Auckland Council consultation

Redvale Landfill Expansion
Responses to Auckland Council Comments
Tranche 1

Table B 1: Response (Andrew Stiles) to Auckland Council (Kyle Li) comments on the Draft Geotechnical Assessment

Table D 1: Responses (Leon Pemberton) to Auckland Council (Stephen Collins – Beca) comments on the Draft Hydrogeological Assessment

Title: Section N2-2025.gsz

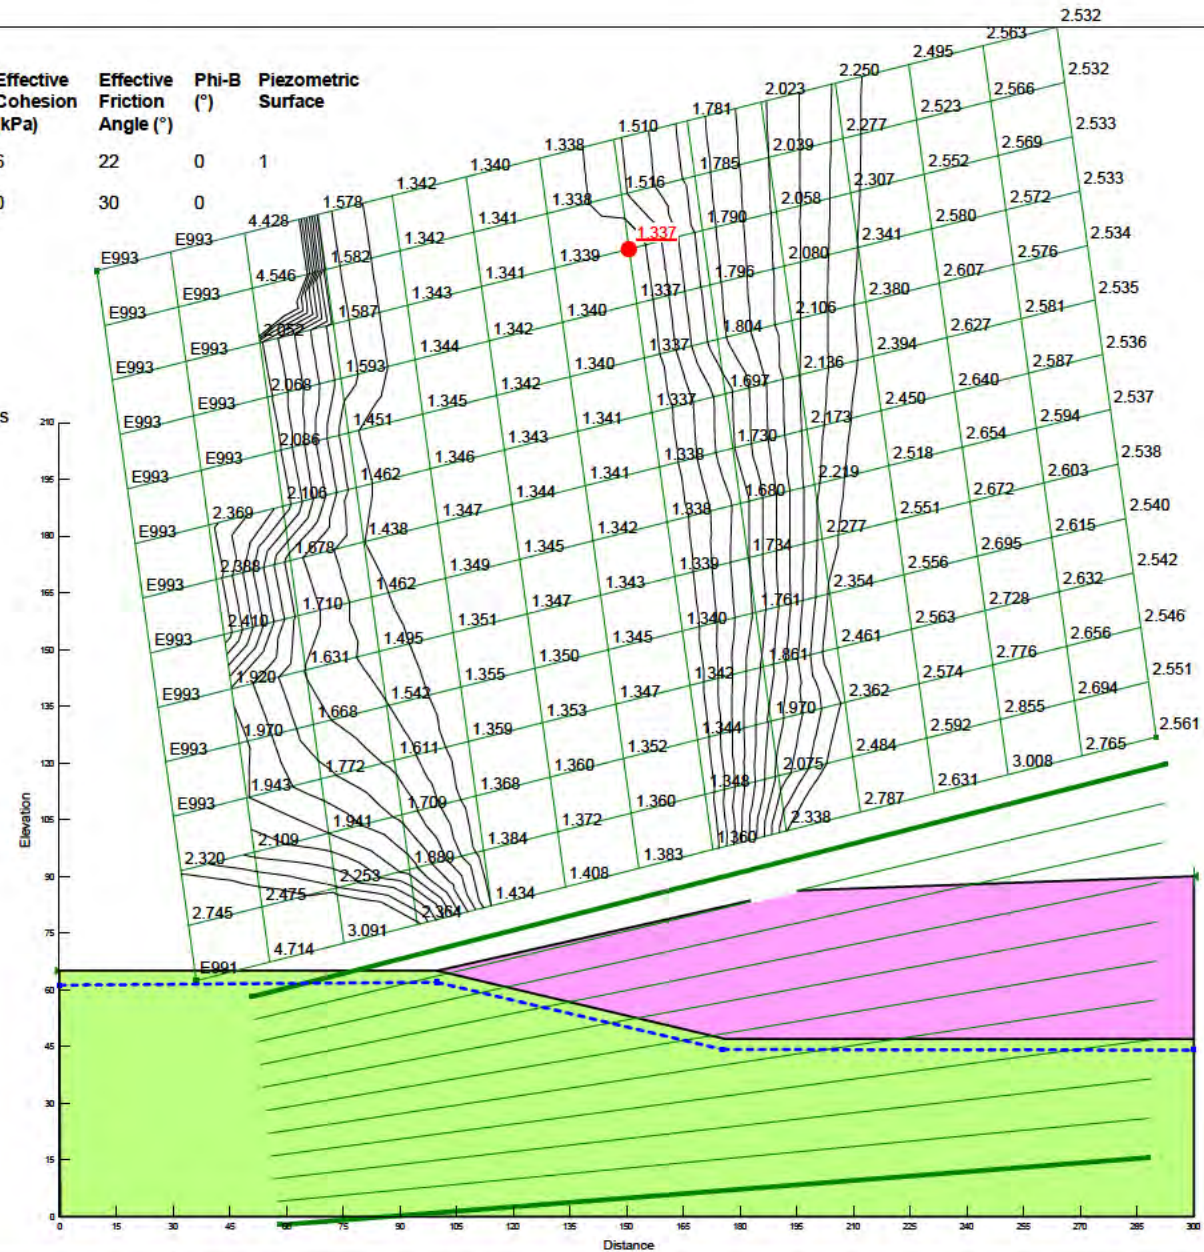
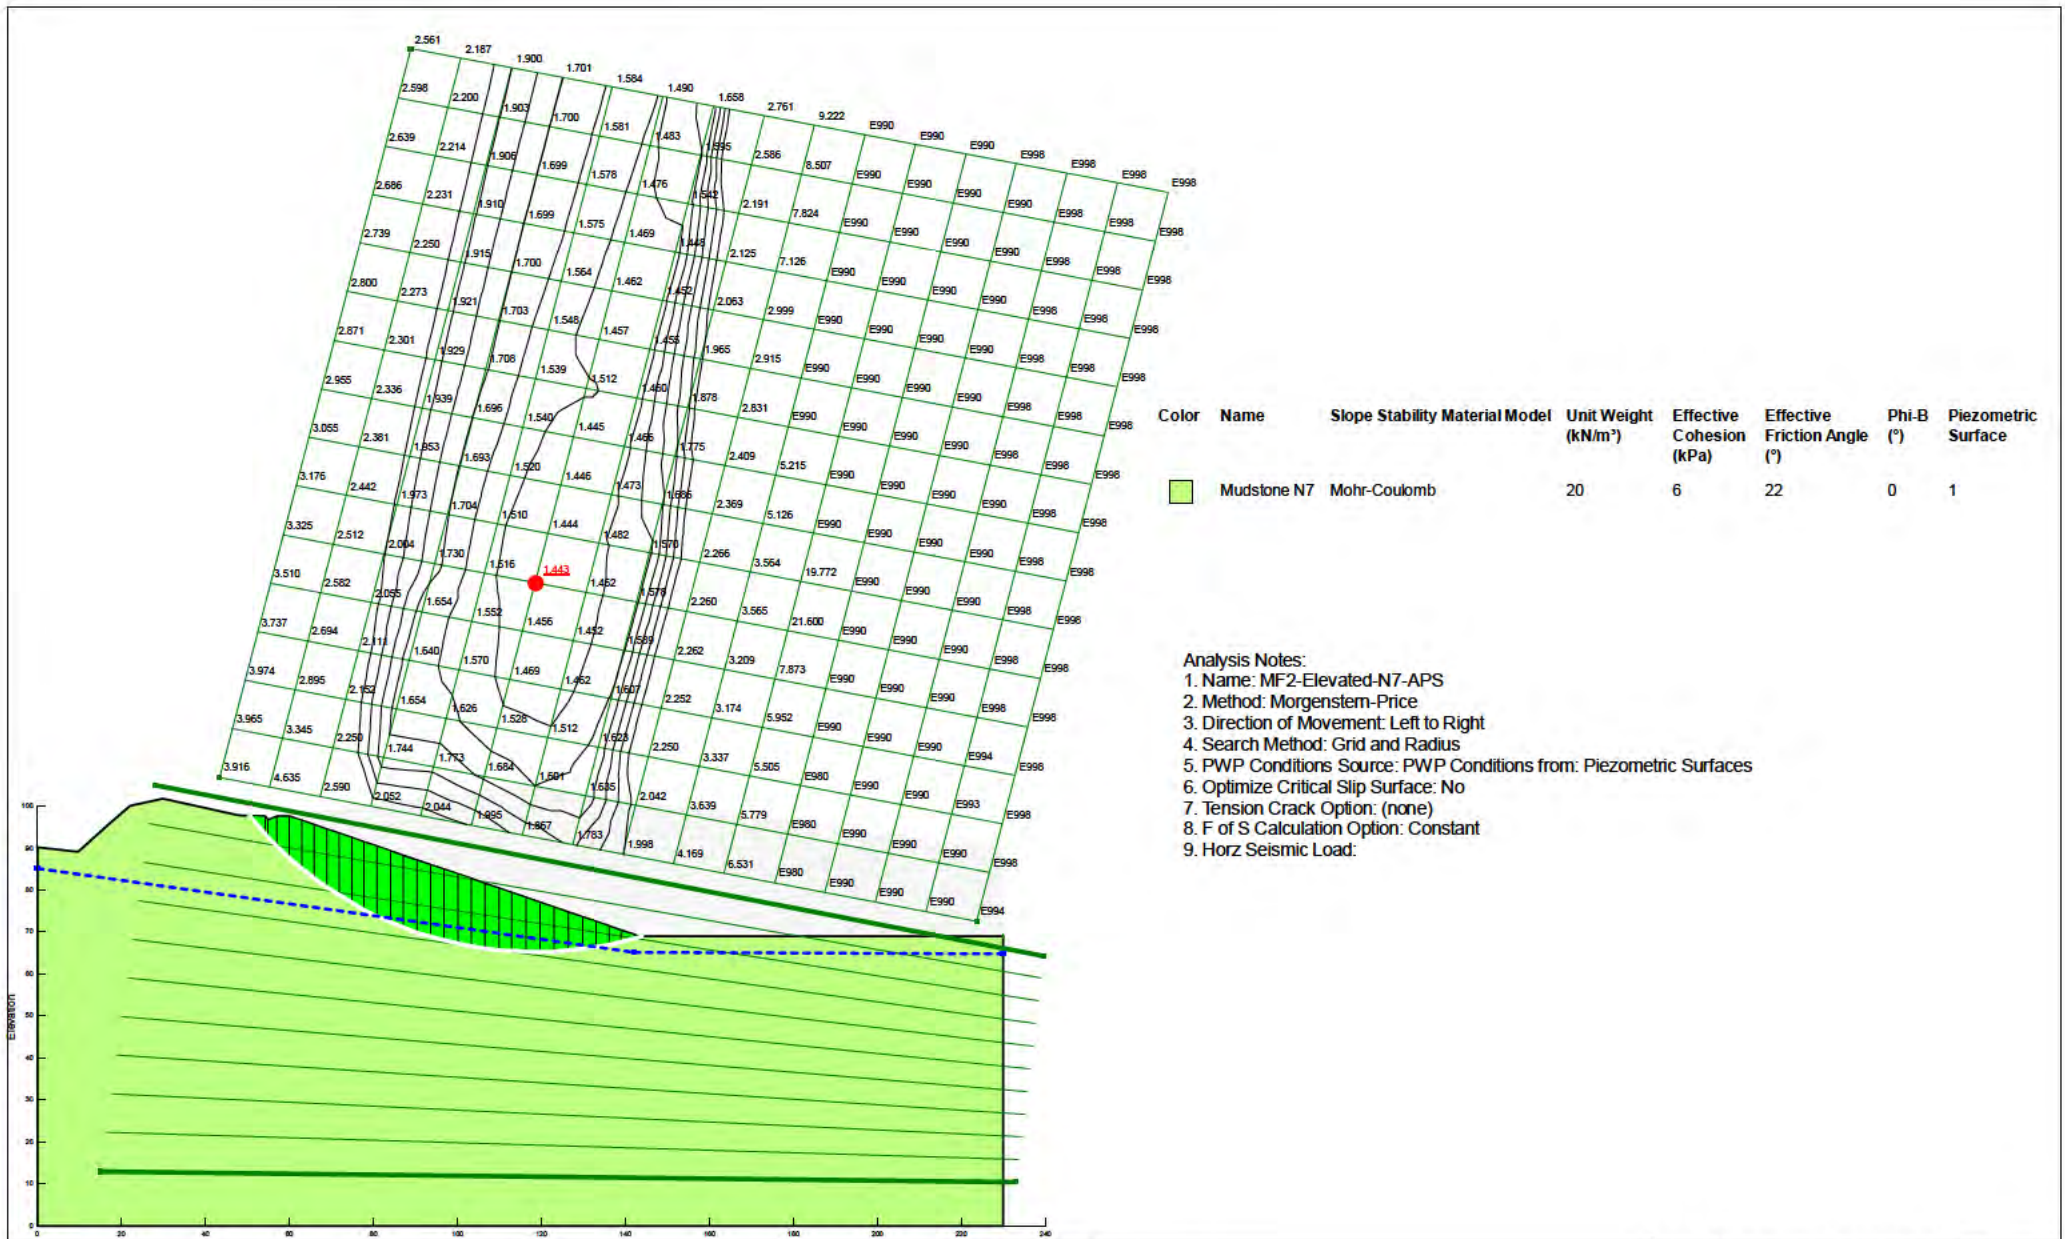
#	Comment	Response														
		The recent EGL investigations, (see Appendix K in the draft Geotechnical Assessment Report), only encountered Pleistocene Sediments in their Boreholes MBH10 to MBH13, on the eastern half of the southern boundary. The materials within those three boreholes were assessed by EGL as stiff to very stiff, occasionally hard, which matches our observations during construction of the cells along the landfill’s south-eastern boundary.														
5	It is noted that, where a factor of safety was less than 1.0 was returned for the seismic load cases, the yield acceleration and slope displacement was assessed using 50th percentile values. However, these assessments were not included within the draft Geotechnical Assessment Report. Please provide the yield acceleration and slope displacement assessments for the slope stability analyses undertaken to provide the seismic displacement results presented in the draft Tonkin + Taylor Geotechnical Assessment Report, dated March 2026.	As discussed in Section 9.2.2 of the draft Geotechnical Assessment Report, where a FoS of less than 1.0 is achieved for the seismic loading conditions, the yield acceleration and slope displacement were assessed as recommended by the Auckland Council Code of Practice (2023). Slope stability FoS of less than 1.0 were assessed for 6 No. of the 9 No. cross-sections analysed and the yield (critical) accelerations for those analyses are summarised below:

<table><tr><th>Cross-section</th><th>Yield acceleration</th></tr><tr><td>MF3</td><td>0.203g</td></tr></table>

As noted in the draft Geotechnical Assessment Report, cumulative displacements were assessed using the methods of Ambraseys and Srubulov (1995), Jibson (2007), and Martin and Qiu (2008), in a similar manner as for the recent ARL assessment. The calculations have been carried out using in-house developed spreadsheets which have been rigorously checked and reviewed as part of our internal QA procedures. An example of the calculation inputs and outputs is shown on Figures Q5-A and Q5-B attached.	Cross-section	Yield acceleration	N1	0.151g	E1	0.212g	E2	0.188g	E3	0.173g	S1	0.155g	MF3	0.203g
Cross-section	Yield acceleration															
N1	0.151g															
E1	0.212g															
E2	0.188g															
E3	0.173g															
S1	0.155g															
MF3	0.203g															
6	It is noted that the critical slip circles grid locations for the slope stability analyses Cross Section N2, DBE seismic case and Cross Section MF2, Elevated GW case, are located at the extent of the grid and therefore may not be representative of the ‘worst-case’ factor of safety. Please amend the slope stability analyses to confirm that the ‘worst-case’ factor of safety for each of the foregoing cross sections have been captured.	We have rerun the Slope/W analyses for the two referenced cases, expanding the grid extent to its practical limit. The revised slope stability plots are attached as Figures Q6-A and Q6-B, and will be included in the updated Report, to replace the current plots. Summarising the results of the re-analyses: - Analysis N2-C1 design GW-N7-APS seismic DBE: Minimum assessed FoS changes slightly from 1.338 to 1.337 - Analysis MF2-Elevated-N7-APS: Minimum assessed FoS changes slightly from 1.435 to 1.443

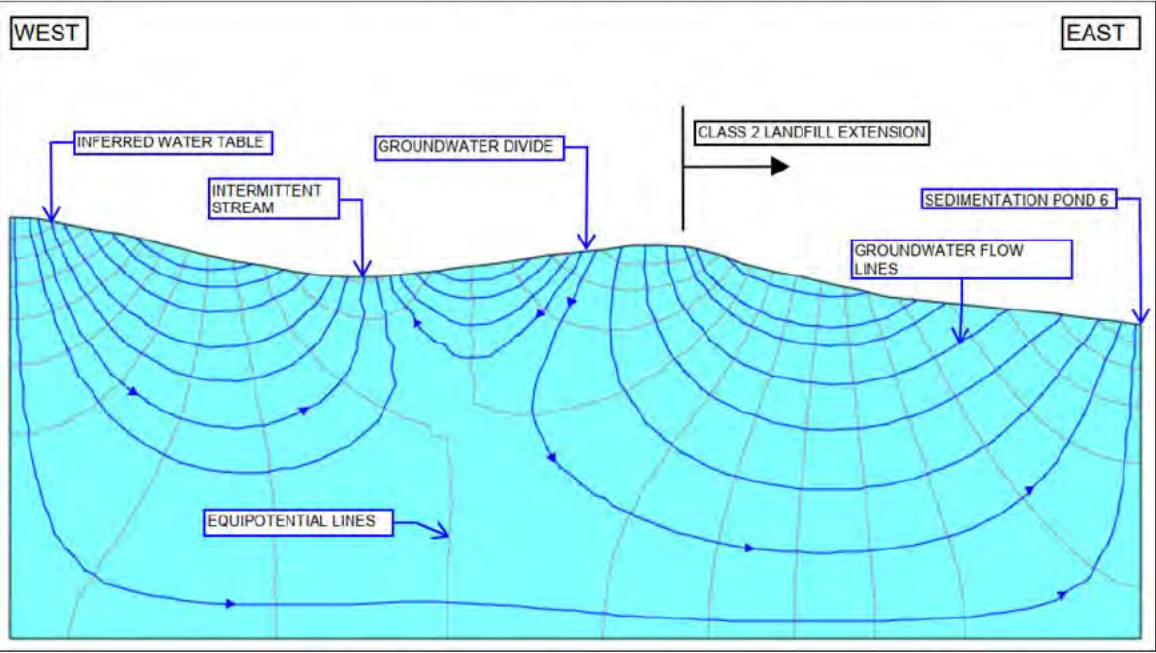
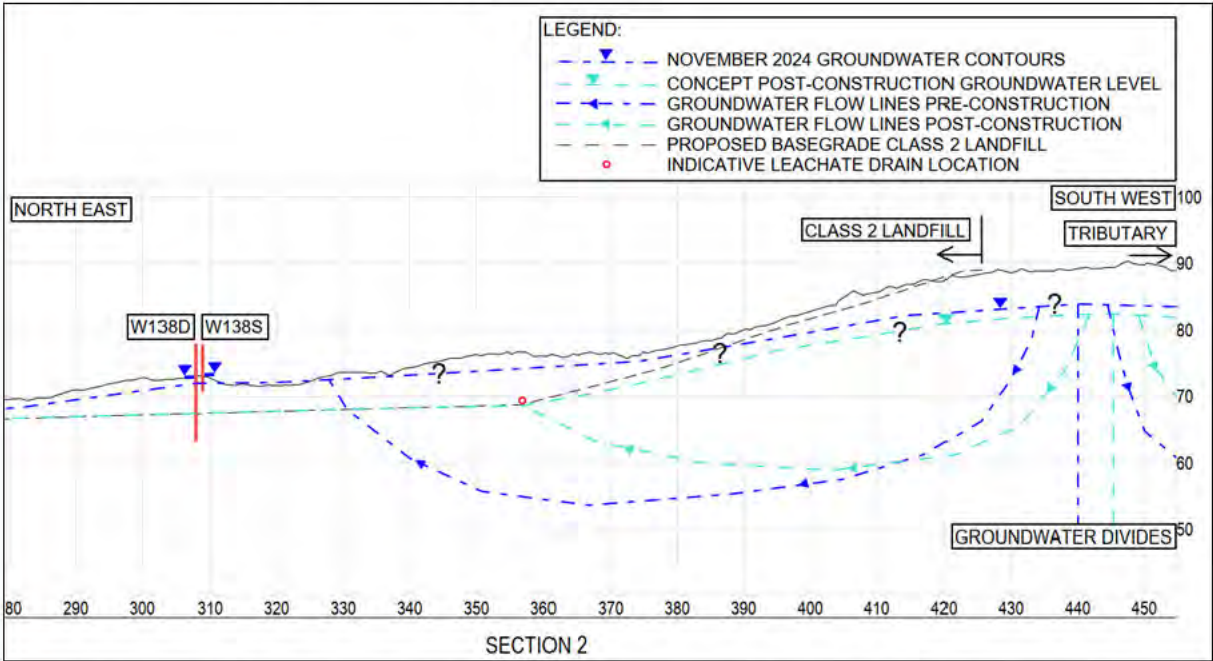
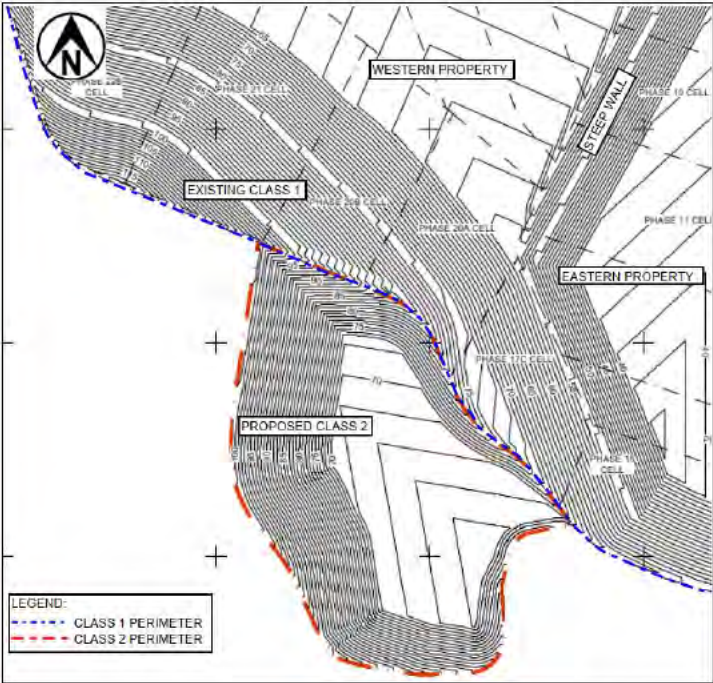
#	Comment	Response
1	A single intermittent tributary of the Rangitopuni Stream is not considered as a potential receptor, despite being adjacent to the Class 2 landfill. This stream was identified in the Ecology Assessment but not identified in the hydrogeology report.	The intermittent tributary of the Rangitopuni Stream is not a groundwater receptor for the existing landfill footprint and the proposed Class 2 Landfill Extension because groundwater beneath the landfill flows away from the tributary under both existing and post-construction conditions. The tributary is located south of Stockpile 4 and west of the proposed Class 2 extension area (Figure D1). Regional groundwater contouring indicates that groundwater flow in the vicinity of the Class 2 extension is generally toward the south-east. This flow direction is away from the tributary and therefore, does not support groundwater discharge or baseflow contribution to the stream.  Figure D1: Location of the tributary of the Rangitopuni Stream in relation to the Class 2 landfill extension. The yellow line indicates WMNZ landholdings in this area. At the site scale, topographic catchments show that the tributary and the proposed Class 2 extension are separated by a ridgeline and lie within different surface water catchments. Consistent with this catchment separation, the tributary is

#	Comment	Response
		located at a higher elevation (approximately 72.7 mRL) than the base of the proposed Class 2 extension (approximately 66–67 mRL). This relative elevation relationship indicates that the tributary is hydraulically up-gradient of the Class 2 Landfill extension. Groundwater catchments are reasonably assumed to be a muted reflection of surface topography. On this basis, a groundwater divide is inferred beneath the ridgeline, separating groundwater flow toward the tributary from groundwater flow beneath the proposed Class 2 extension. The groundwater flow expected beneath the intermittent stream and proposed Class 2 extension in the existing setting is illustrated on Figure D2, drawn along line of Section 3 (refer Figure D3).  Figure D2: Inferred groundwater flow lines beneath the water table conceptualised as a muted reflection of topography in the existing setting, generated using TopoDrive proprietary software¹. Arrows indicate the direction of groundwater flow. Construction dewatering associated with the Class 2 extension has been assessed using Anaqsim². The modelling predicts that after 365 days of dewatering, the drawdown extent toward the tributary remains very limited and extends only

#	Comment	Response
		marginally beyond the Class 2 extension footprint, approaching but not materially crossing the ridgeline (Figure D3). Dewatering is predicted to slightly steepen the groundwater flow contours toward the excavation and shift the groundwater divide slightly toward the tributary. This change is unlikely to result in groundwater flow beneath the proposed landfill reversing toward the tributary. Groundwater beneath the Class 2 extension is predicted to continue flowing away from the tributary under both existing and dewatered conditions. Post-construction, the lining system of the Class 2 extension will create a low-permeability barrier that will reduce local groundwater recharge currently occurring within the landfill footprint. A reduction in recharge is expected to result in a lowering of groundwater levels adjacent to the Class 2 extension, maintaining the shift in the groundwater divide toward the tributary, created during dewatering. Whilst the divide is likely to move closer to the tributary, groundwater flow beneath the Class 2 extension is unlikely to significantly change compared to the existing setting shown in Figure D2 and is thus expected to continue to flow away from the tributary, as illustrated on Figure D4.  Figure D3: Predicted groundwater drawdown extents around the Class 2 Landfill extension during dewatering. Section line 2 is shown in part on Figure D4.

#	Comment	Response
		Based on predicted changes to local groundwater levels during and post-construction of the Class 2 extension, and the relative elevation differences between the tributary and the floor of the landfill, the intermittent tributary of the Rangitopuni Stream was not identified as a potential receptor.  Figure D4: Concept reduction in groundwater levels post-construction of the Class 2 Landfill extension. Dashed black line is the Class 2 extension footprint, the dashed blue line is based on the November 2024 groundwater contours and the dashed cyan line represents the concept post-construction groundwater levels.
